**SUBJECT: COMANCHE PEAK NUCLEAR POWER PLANT, UNITS 3 AND 4
DOCKET NUMBERS 52-034 AND 52-035
RESPONSE TO REQUEST FOR ADDITIONAL INFORMATION NO. 4312 AND 4314**

Response to Request for Additional Information No. 4312 (CP RAI #144)

Response to Request for Additional Information No. 4314 (CP RAI #147)

Figure 1-2 Cross-Section 3a

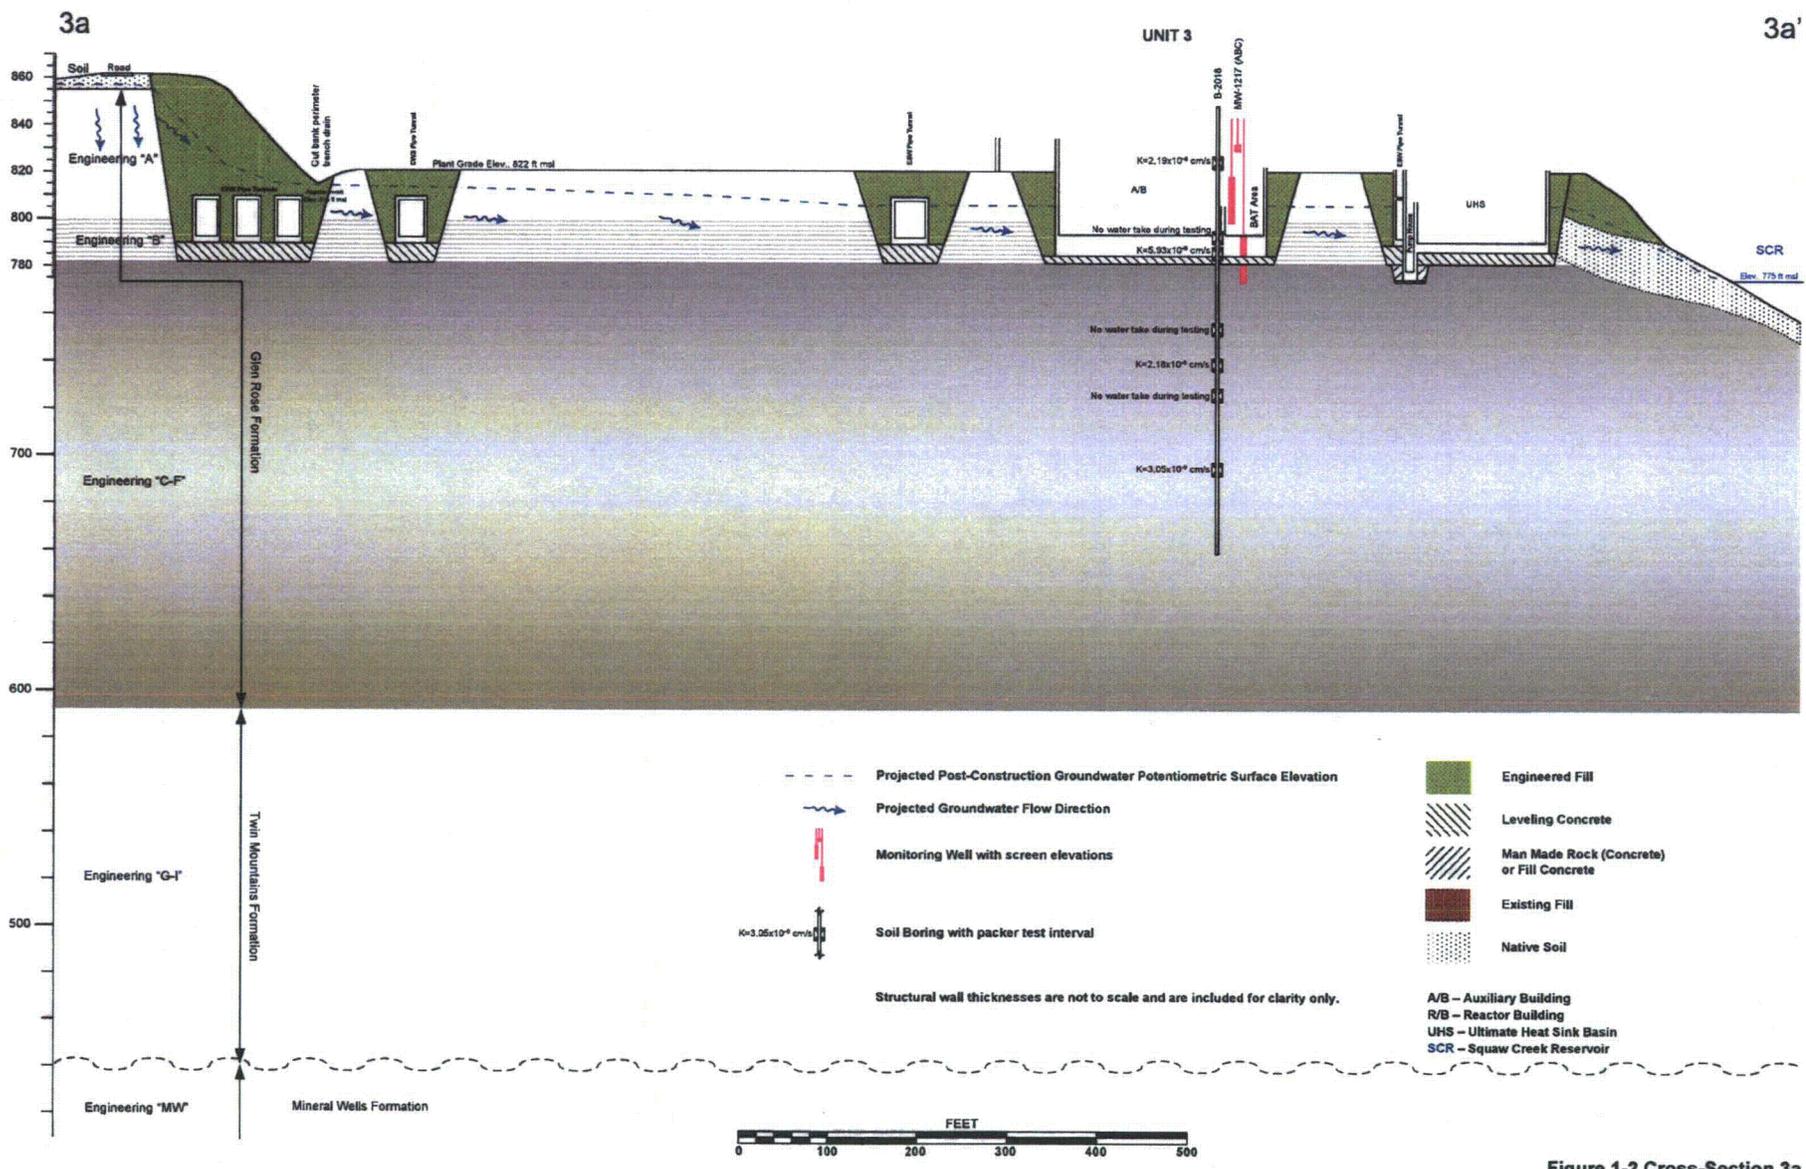
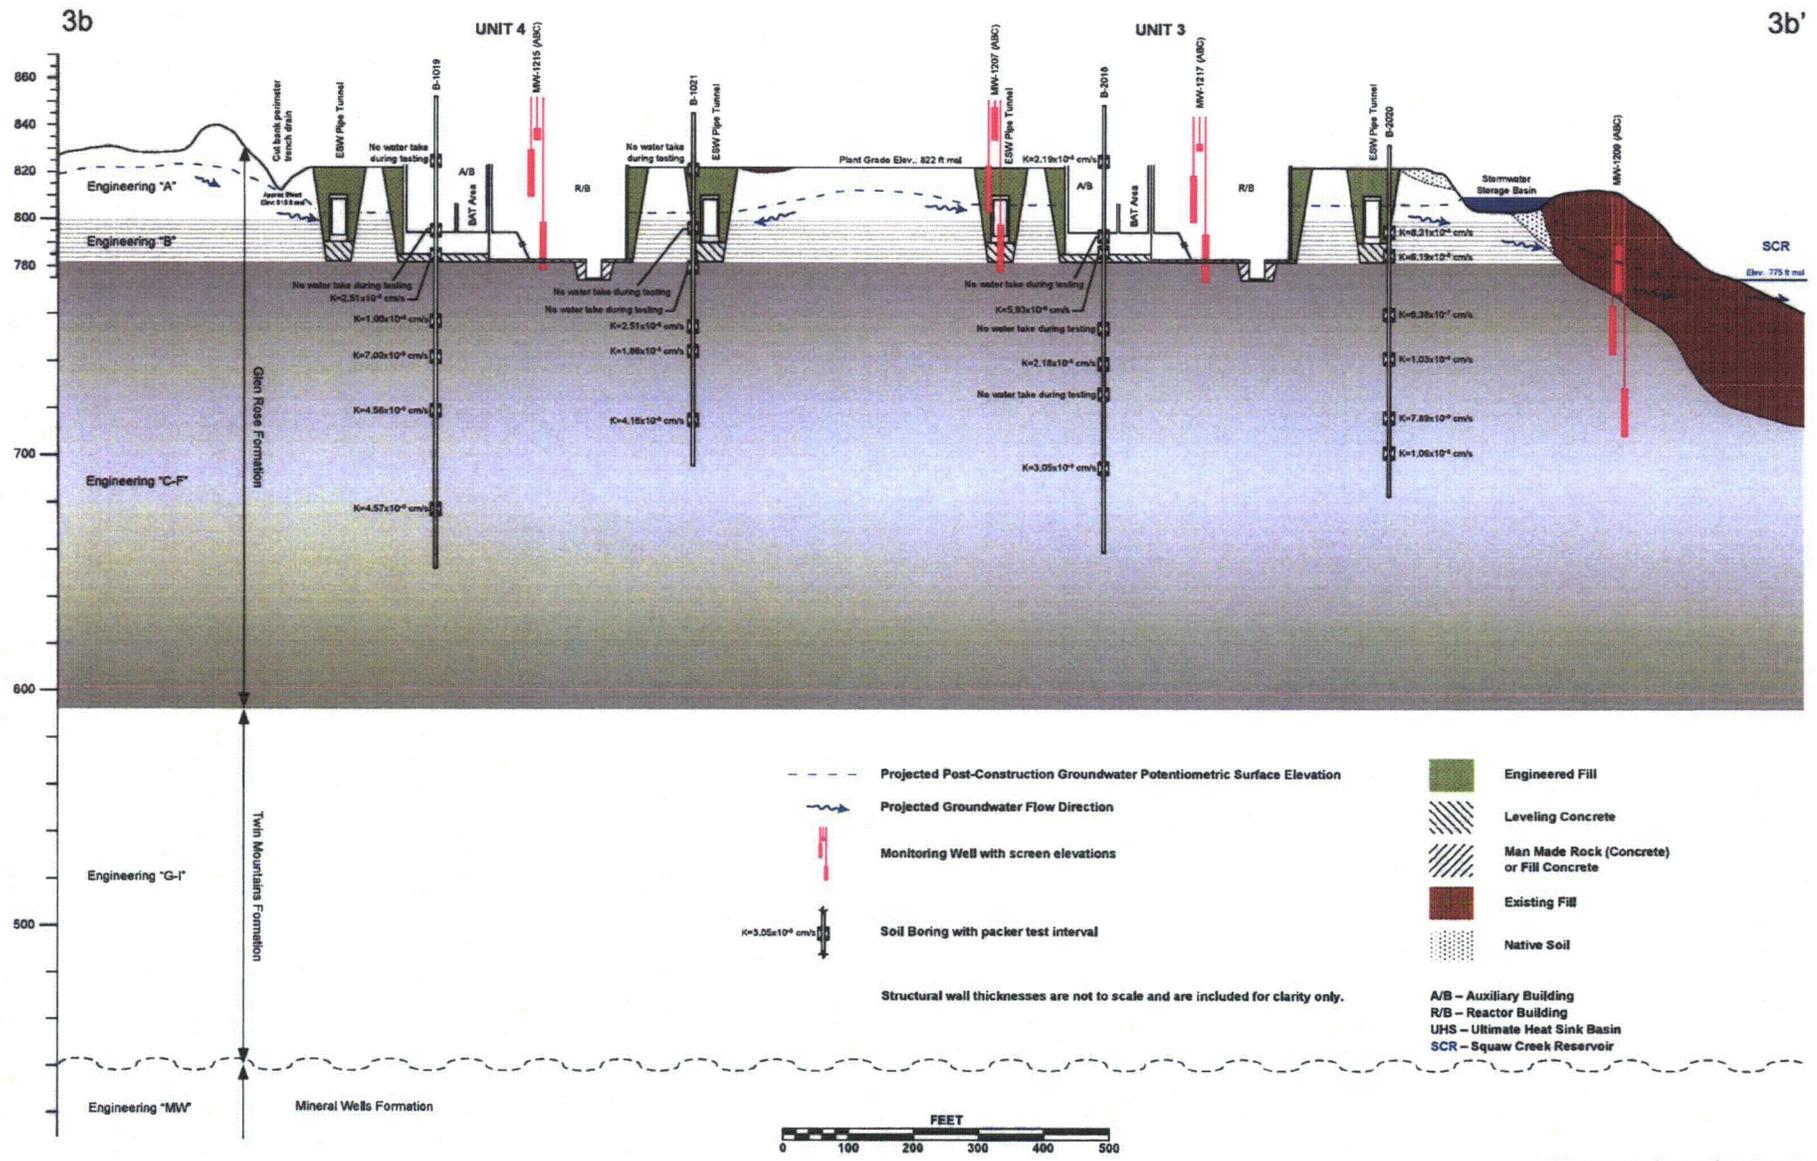
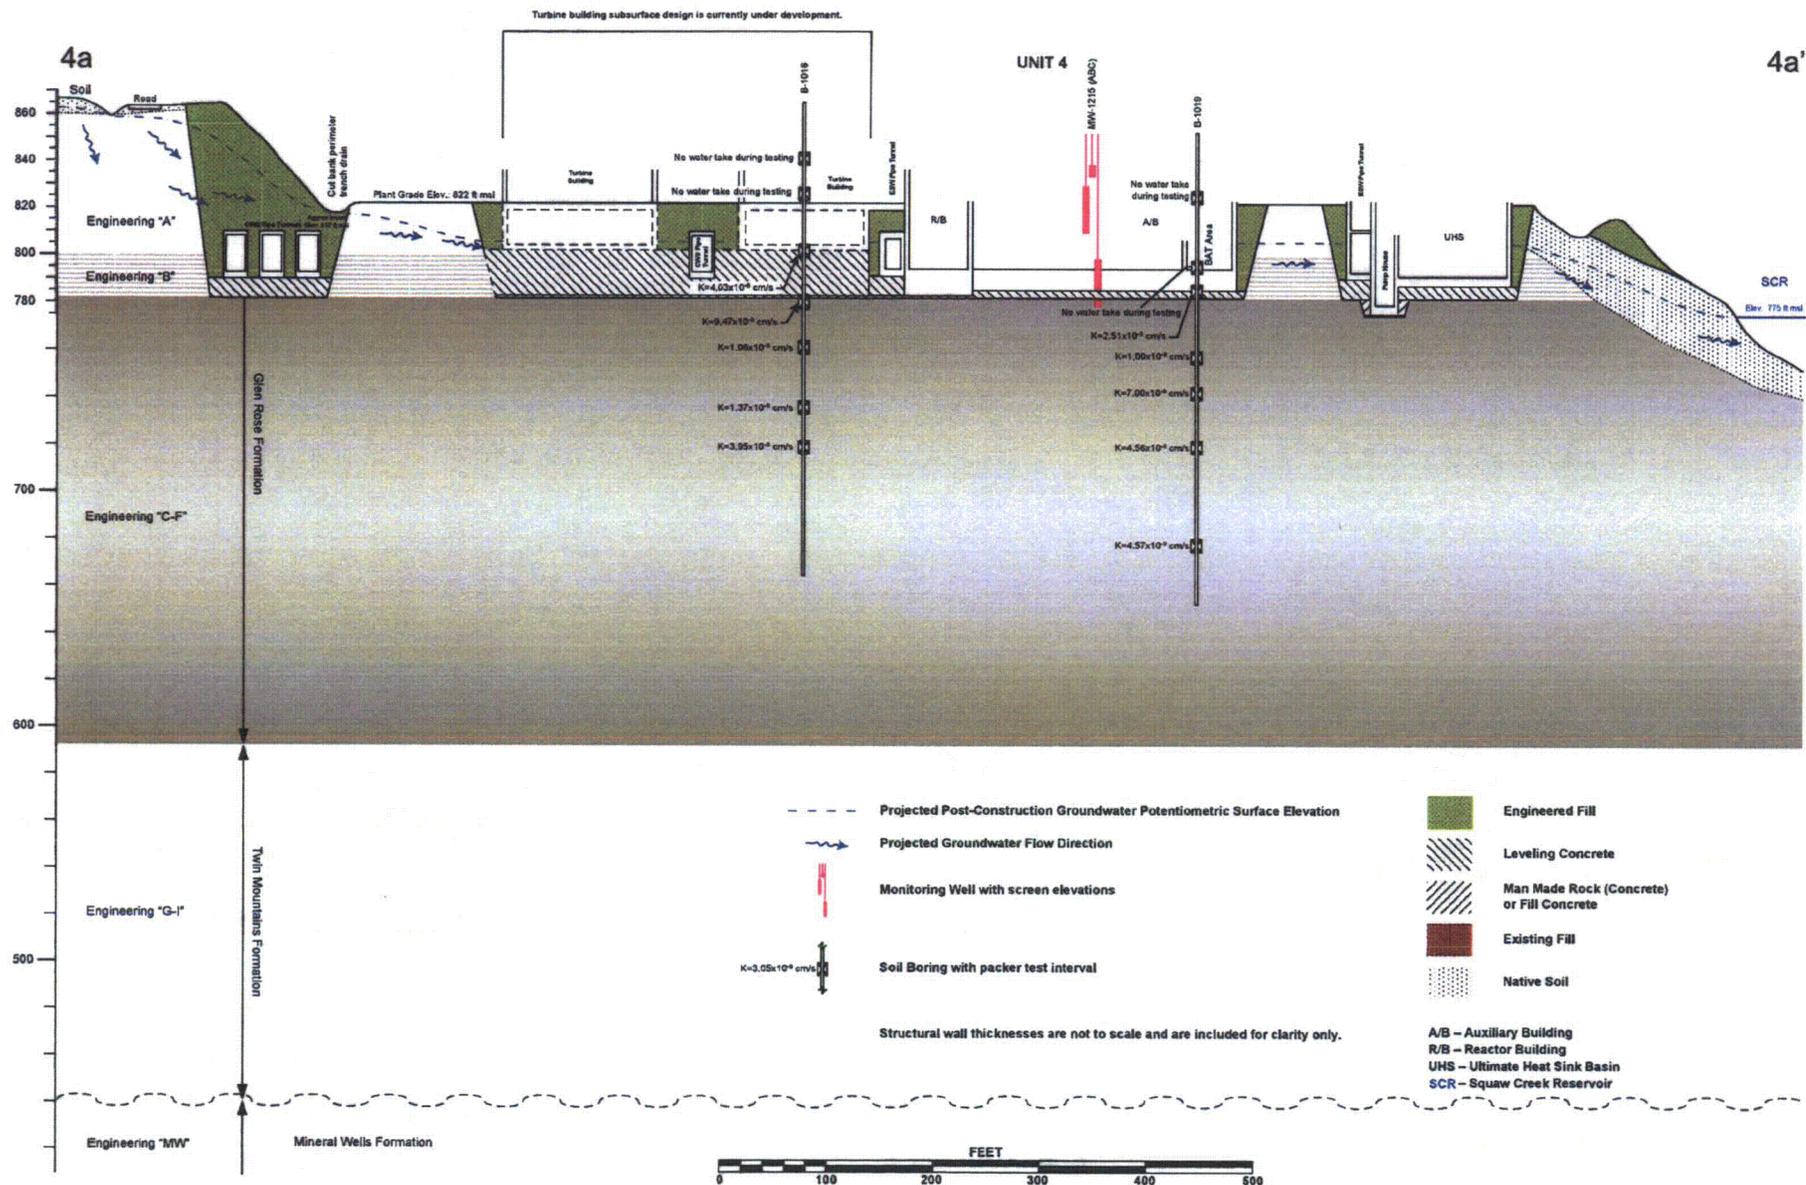
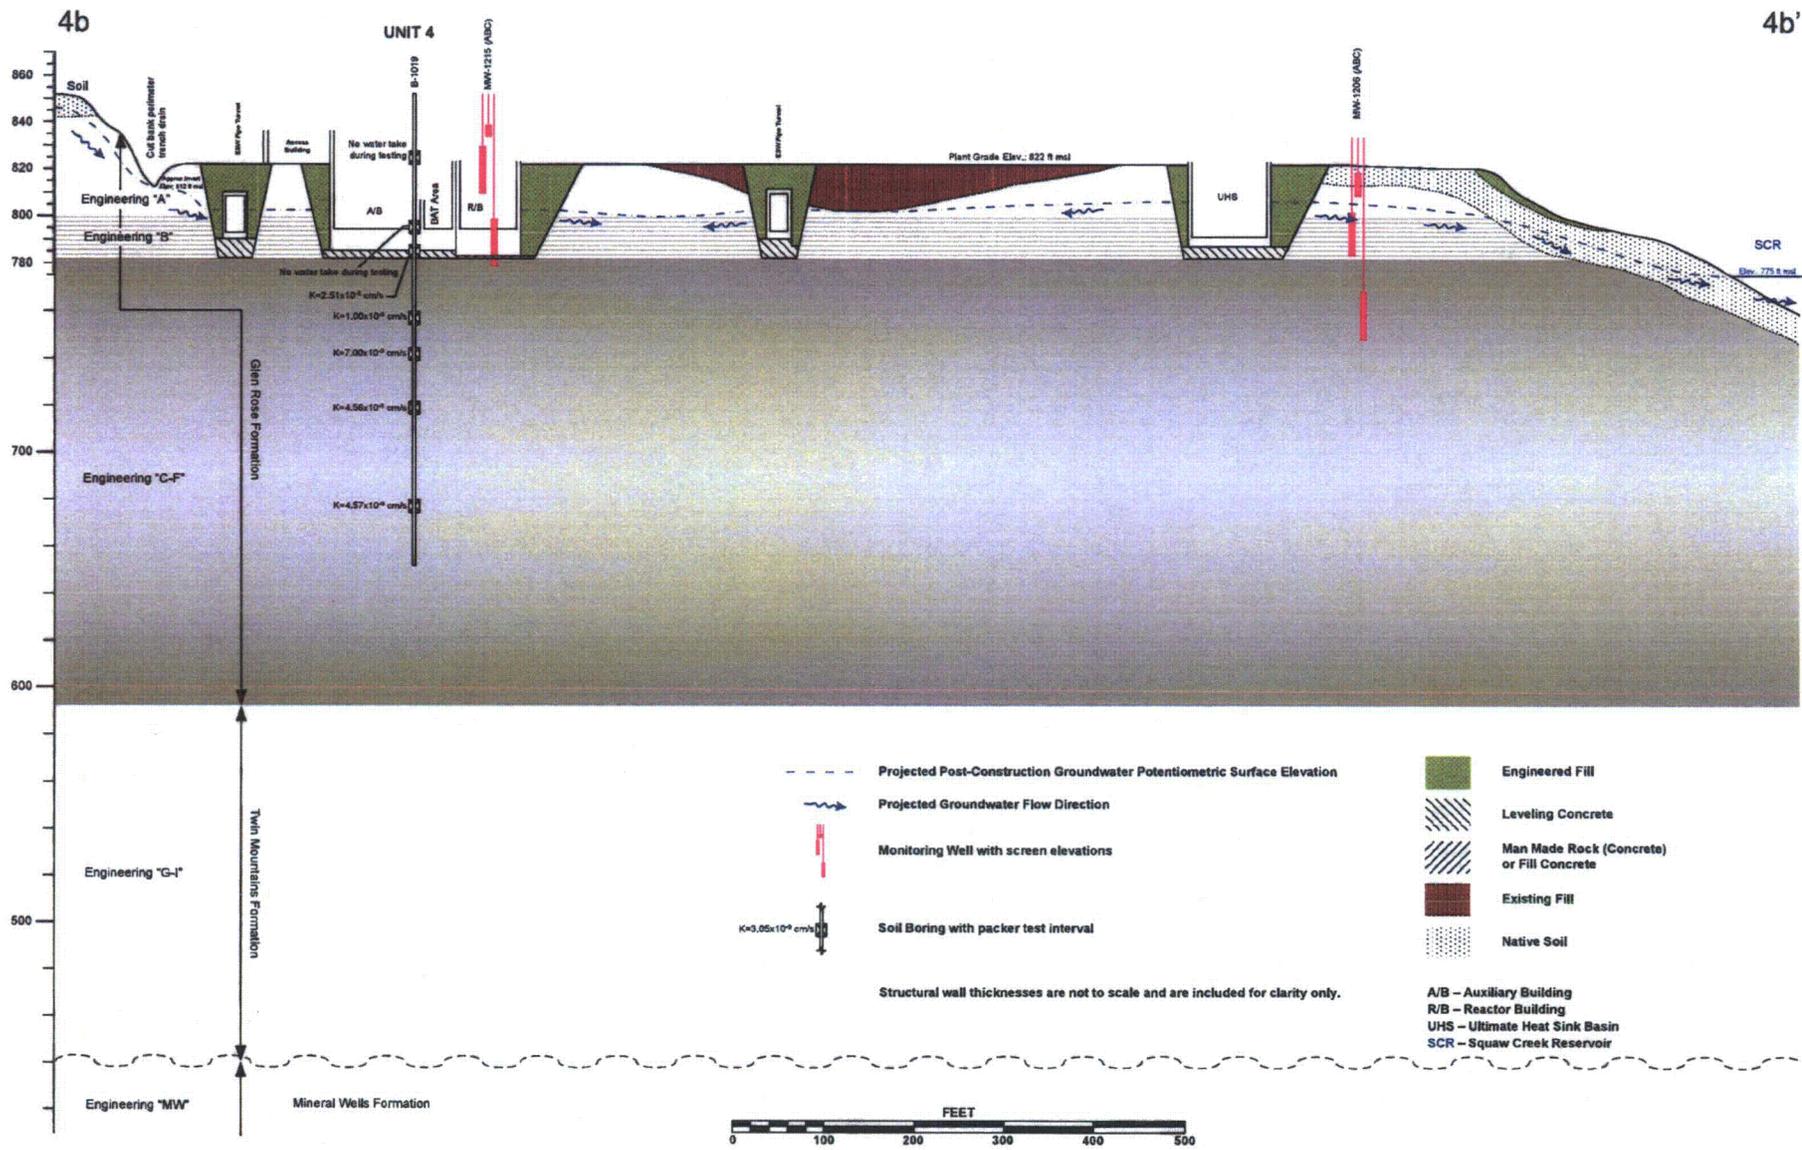
The staff acknowledges that cross-sections were included in the applicant's response as Figures 2.4.12-213 and 2.4.12-214 and Figures 2.5.4-209 through 211. While these cross-sections contain useful and related information they do not satisfy the intent of the original RAI, which was to illustrate the post-construction conceptual site configuration by incorporating description of conceptual hydrologic conditions (such as groundwater levels, flow directions, etc.) and site hydrogeology with associated well or boring control points through the Twin Mountains Formation on one set of cross-sections.

Information provided in the cross-sections does not clearly show the anticipated surface and groundwater conditions. The flowpaths presented in these cross-sections are simple straight lines with little documentation or maps to support the selection of these specific pathways as the most probable result of post-construction conditions. The interaction between surface water and groundwater is important and there are insufficient details on expected interactions post-construction.

In order to make its safety determination based on adequate characterization of the site, the NRC staff requests that the applicant provide cross-sections through the centerline of each proposed reactor area which present on the same figure the post-construction site configuration, hydrogeological units beneath

the site (including the Twin Mountains Formation and bedrock transition zone found in the Glen Rose), monitoring wells and borings used as control points and probable directions of groundwater movement. Also provide maps displaying post-construction site features and conceptualize post-construction groundwater conditions.

Figures 1-2 through 1-5 provide the requested information. The cross-sections are defined on Figure 1-1 attached to the response to Question 02.04.12-9 above
